**SUBJECT: NORTH ANNA POWER STATION - NRC EXAMINATION REPORT
NOS. 50-338/2002-301 AND 50-339/2002-301**

NRC's RESOLUTION TO THE FACILITY'S POST EXAMINATION COMMENTS

TREND FOR TEMGRP01
 ** dynamic group **

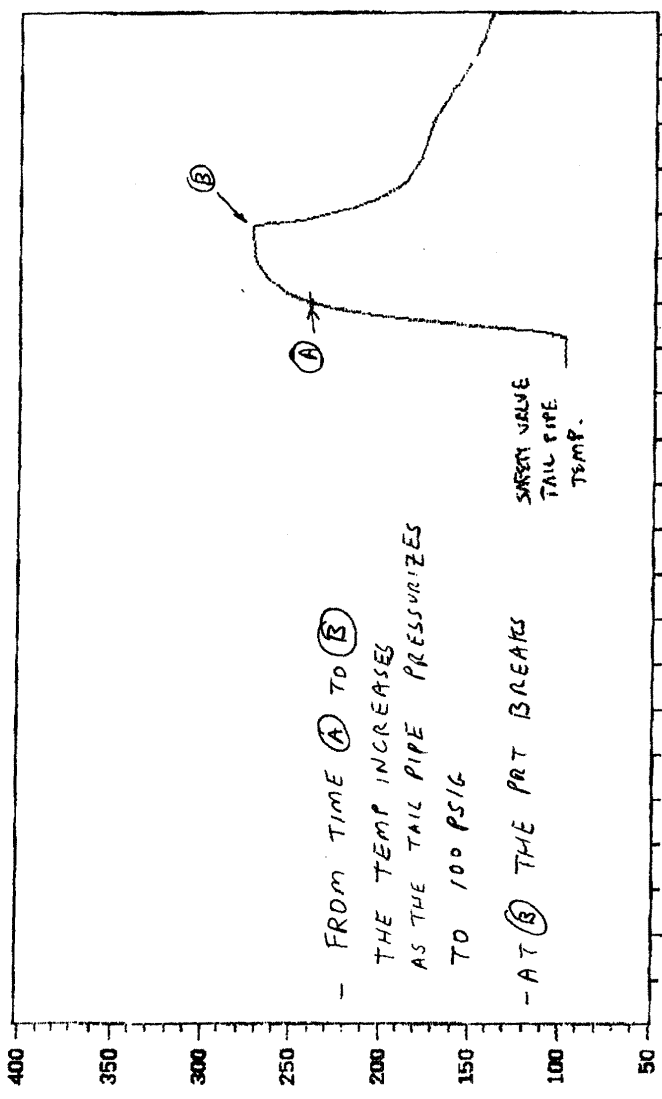
Facility comment to RO/SRO Question #15 NOT accepted: In accordance with NCRODP-74-NA, the steam undergoes an extremely rapid expansion which is almost isenthalpic (BTUs of energy per pound mass remain constant). The expansion causes the BTUs to be contained in a much larger volume. Temperatures will indicate between 200 and 300 degrees F. Based on the initial conditions, RCS temperature and pressure will decrease and stabilize out long after the reactor trip and after the PRT rupture disc breaks. Since enthalpy is basically constant across the safety valve, tail piece temperatures will increase to around 200 and 300 degrees F, then continue to increase slowly until the PRT rupture disc breaks. The tail pipe temperatures will start to decrease proportionately with the drop in RCS pressure and temperature.

Based on the facility's post exam comment: The NRC requested the facility to set up and run a test on the simulator in order that a graph of tail piece temperature vs time could be created for reference. This graph is included as Attachment 1 to this enclosure. Based on the time increments, answer "D" is the only correct answer for the following reasons:

1. Each time increment on the trace appears to be ~ 40 seconds. This results in the following rates of temperature increase:
 - a. Temp increase from temp of ~100 degrees to ~ 265 degrees occurs over ~1st 40 seconds for a rate of ~248 degrees/minute. Note that 100 degrees appears to be temp just prior to safety opening.
 - b. Temp increase from 265 to ~peak temp of ~275 occurs over ~50 seconds for a rate of ~12 degrees/min.
 - c. Temp decrease from ~275 to ~175 occurs over ~ 70 seconds for a rate of ~85 degrees/minute.

Therefore, given these rates of temp increase and decrease, the NRC believes that it is not reasonable to credit answer "C" as correct. The second part of distractor "C", (...and then **slowly** decrease) would not appear to reasonably describe the rate of temp decrease after the PRT rupture disc breaks. Answer "D" is valid based on the first two temp increase rates described above - "increase to between 200 and 300 and then slowly increase."
